Submission on Ballinlee Wind Power Plant (An Coimisiún Pleanála Ref. PAX91.323780)

Project: Ballinlee Wind Power Plant

Executive summary — reasons for objection

T1, T2 & T3 mapped above with adjacent neighbouring properties.

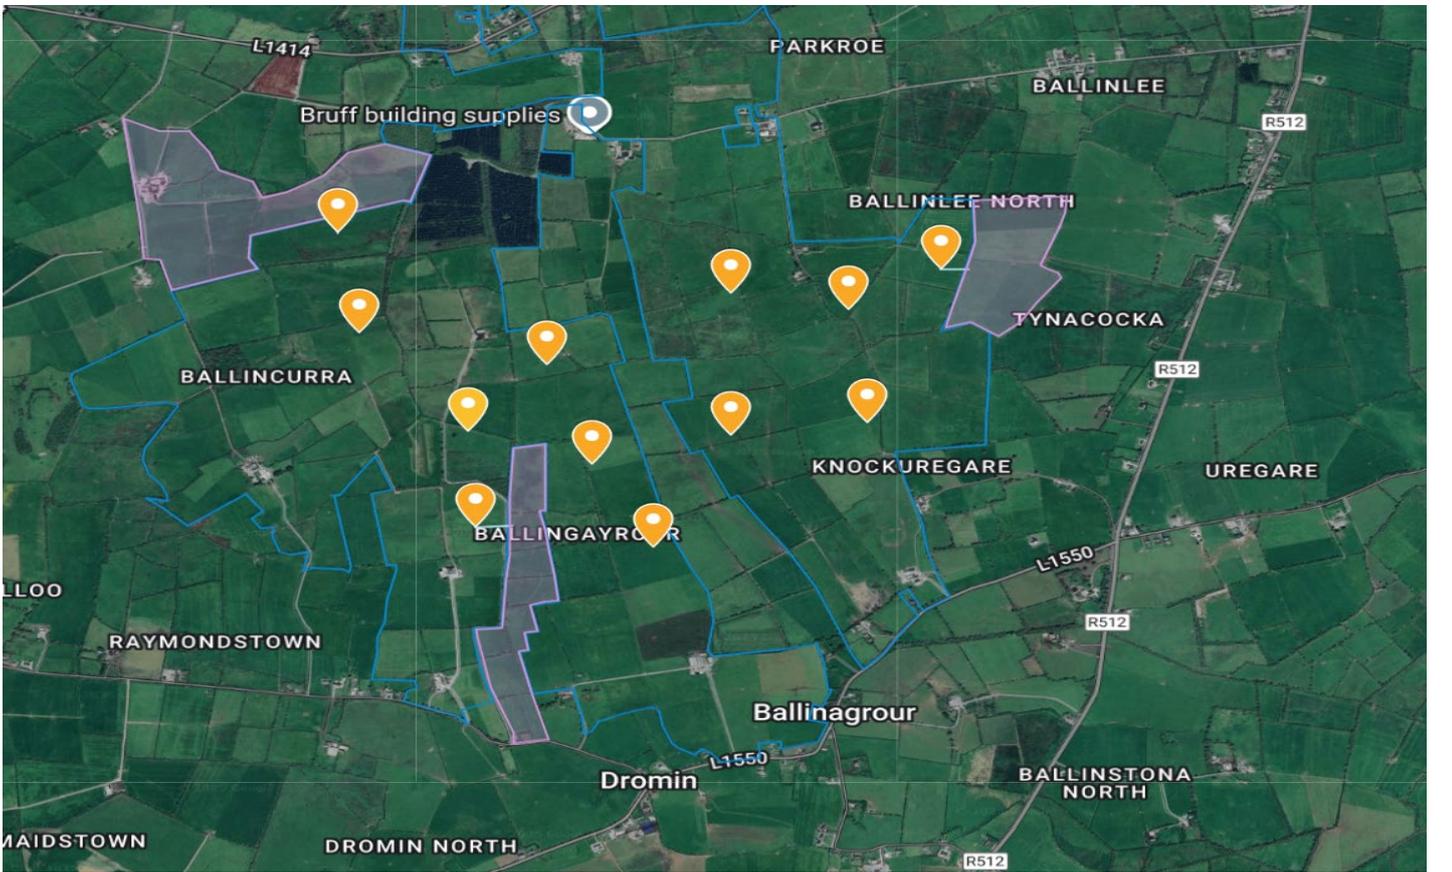
Adjoining Boundary Folio No.	Turbine	Distance	Unit
LK13481	T1	110	m
LK4858	T2	110	m
LK7387F	T2	130	m
LK12589	T3	88	m
LK7387F	T3	82	m
LK1992F	T5	128	m
LK4915F	T6	80	m
LK71	T9	104	m
LK6256	T15	81	m

Consent letters from the above adjoining Folio owners agreeing to a lesser distance of two rotor blades have not been submitted in the applicant submission. It is not clear if consent has been obtained from the adjoining property owners and the applicant failed to submit letters confirming this or if the adjoining landowners are unaware of the proximity of the relevant turbines to their boundary, either way the applicant submission is incomplete and it fails to comply with both the Wind Energy Development Guidelines 2006 and the Draft Revised Wind Energy Development Guidelines December 2019.

- 1) There are nine instances in the applicant submission where the location of a turbine is less than two rotor blades from an adjoining landowner's boundary.
- 2) Consent letters from the said adjoining landowners agreeing to a distance less than two rotor blades have not been submitted by the applicant. The applicant submission is incomplete in this regard.
- 3) The applicant submission fails to comply with both the Wind Energy Development Guidelines 2006 and the Draft Revised Wind Energy Development Guidelines December 2019 despite various references to compliance with same in the applicant submission.

Figure 14-5: Location of heritage structures listed in NIAH and RPS within 3km radius study zone.

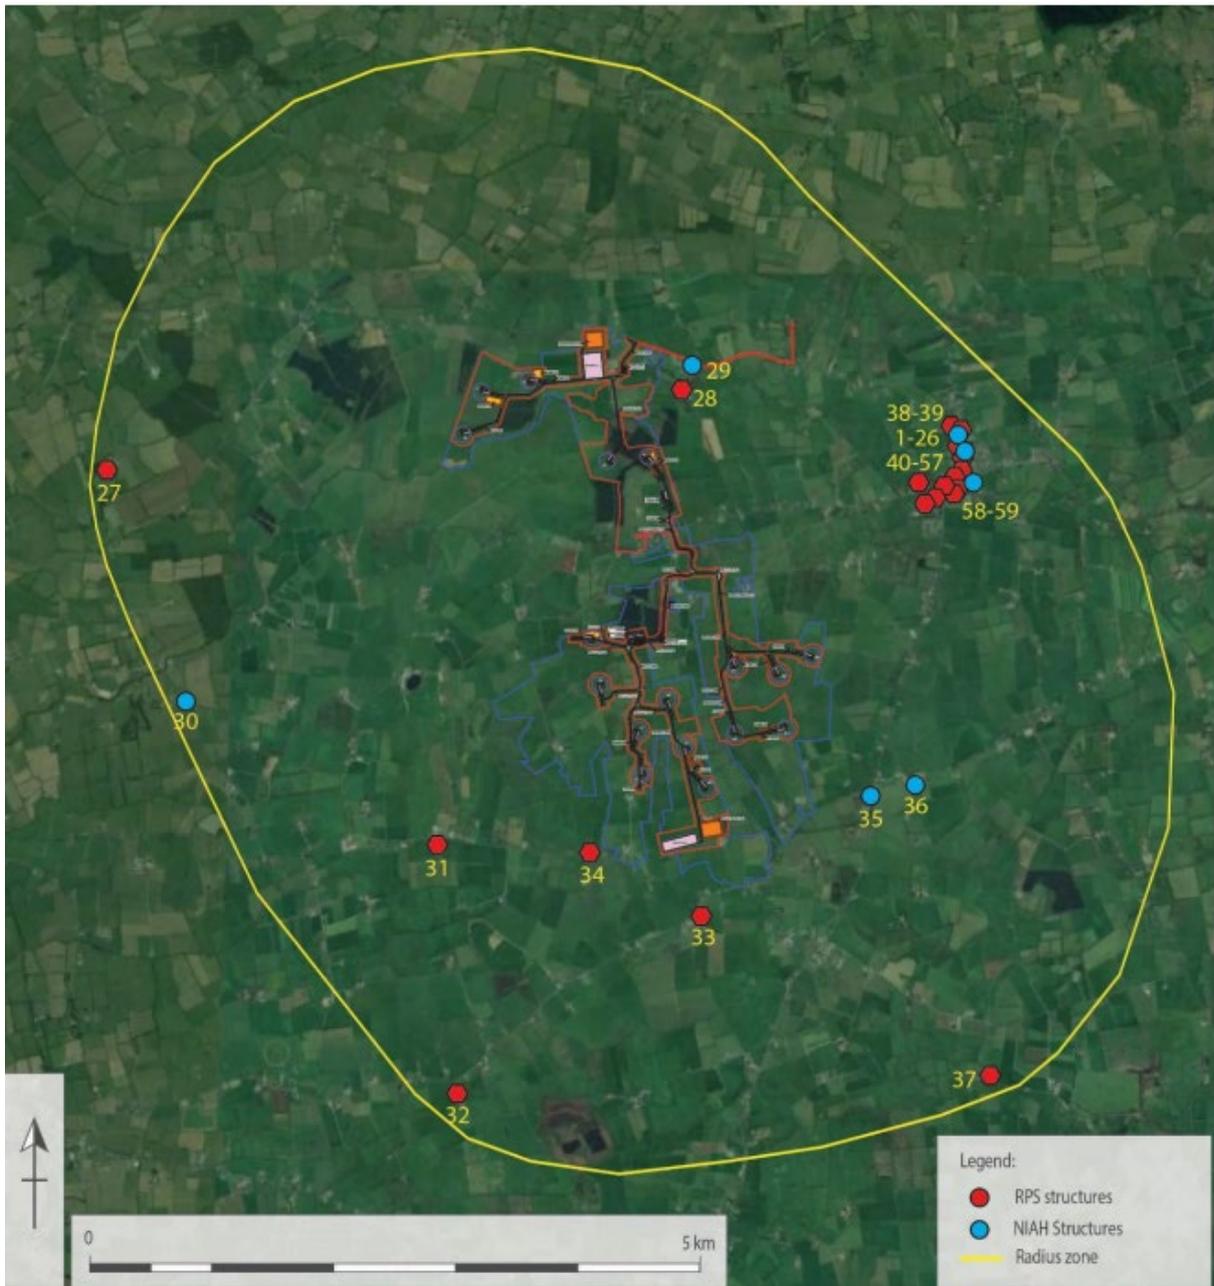
The proximity of the proposed development to Structure No. 34 does not align with **Objective EH O50** of the Limerick Development Plan 2022-2028. The sheer density of recorded monuments in the 3km study area means the area is unsuitable for the proposed scale of this strategic infrastructure development. Strategic infrastructure cannot be developed at the sacrifice of our cultural heritage. There are no mitigations that can alleviate the impact on the nearby castles, thatched cottages, churches and other relative structures in our beautiful rural area.

7.)The applicant submission does not align with the provisions of **Objective EH O50** of the Limerick County Development Plan in so far as it does not ensure that development proposals to Protected Structures, their curtilage and setting, shall have regard to the Architectural Heritage Protection Guidelines for Planning Authorities published by the Department of the Arts, Heritage and the Gaeltacht. It is an objective of the Council to “ensure that any development, modification, alteration, or extension affecting a Protected Structure **and/ or its setting**, is sensitively sited and designed and is appropriate in terms of the proposed scale, mass, height, density, layout and materials” and also that the “Protected Structure and any complex of adjoining buildings, designed landscape features, or views and vistas from within the grounds of the structure are respected”.

Figure 2-6: Wind Energy Zoning

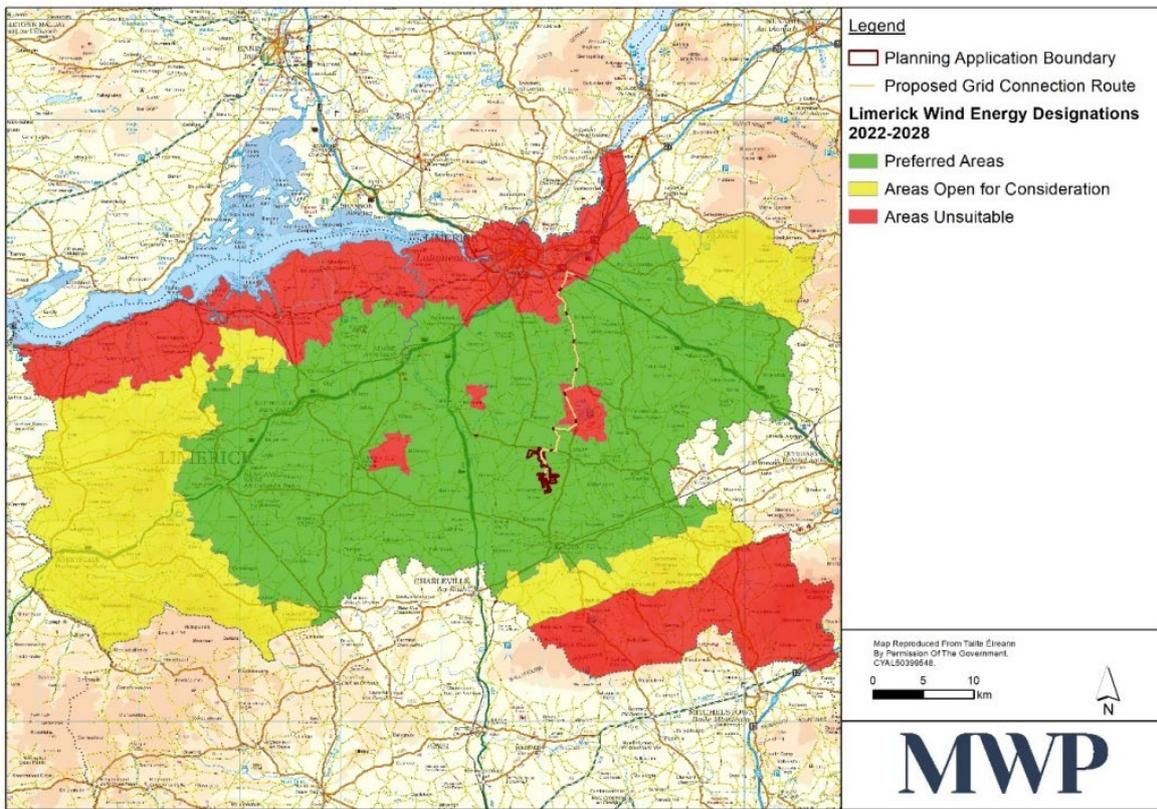
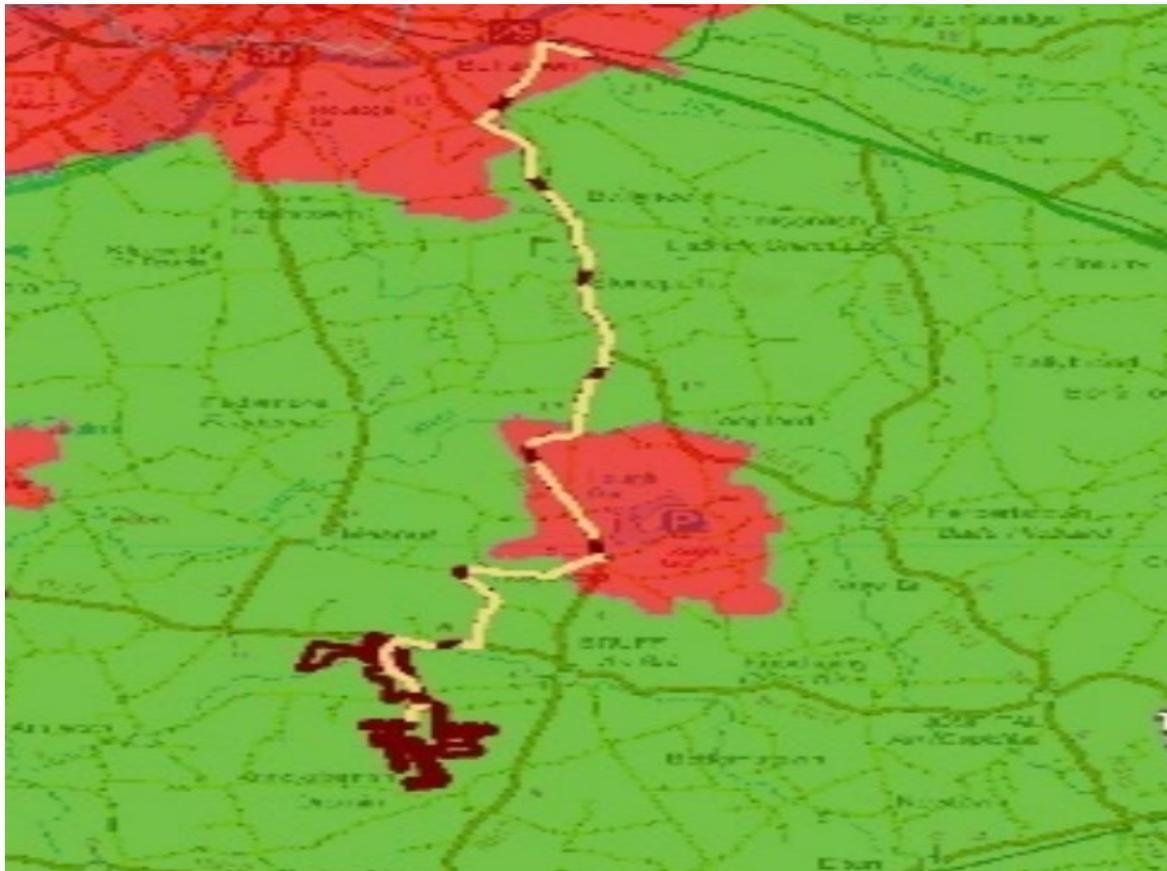
This Planning Statement contains an internally inconsistent interpretation of the Limerick Development Plan 2022–2028 Wind Energy Strategy, particularly regarding the application of zoning designations to the grid connection element of the development.

The Limerick Development Plan 2022–2028 identifies lands “Preferred for Wind Energy Development,” “Open for Consideration,” and “Unsuitable for New Wind Energy Development.” Approximately **6km (22%)** of the 27.6 km GCR traverses land zoned “*Unsuitable for New Wind Energy Development.*”

By asserting that the zoning does not apply to the grid connection, the applicant seeks to rely on the Development Plan for the main site’s policy support while disregarding it for the GCR elements. This approach undermines both the integrity of the Development Plan’s locational strategy and the principle of consistent spatial planning.
